# Site Accessibility Evaluation

### Centennial Park

**Accessibility Evaluation**

SUBJECT: Centennial Park Self-Evaluation

### Finding: 1

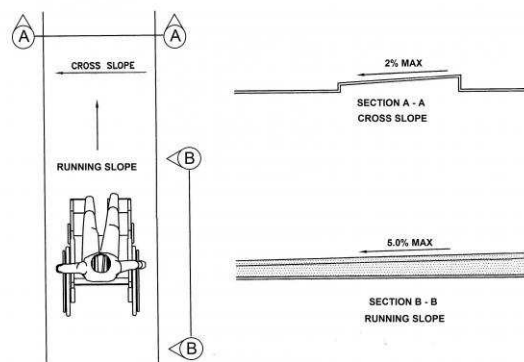
The accessible path of travel has cross slopes greater than 2%.

There are 36 pads of concrete on the route that runs along El Morro with excessive cross-slope measuring as high as 3.7%. 13 were measured at 3% or more.

Remove and replace pads of concrete to compliance.

### Finding: 2

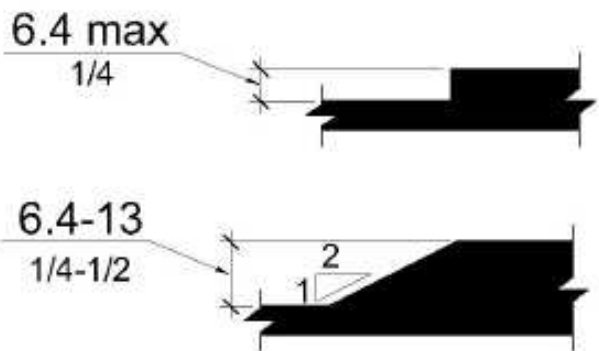
The water main is recessed on the sidewalk. The recess is 20x20x2" deep and has cross slopes in the 9-10% range.

The surface of the pedestrian access route has vertical discontinuities greater than 1/2 inch or between 1/4 inch and 1/2 inch that are not beveled.

At this water main in the sidewalk, the sidewalk reduces to 33" wide.

Remove and replace the sidewalk panel, and increase the height of the water main access.
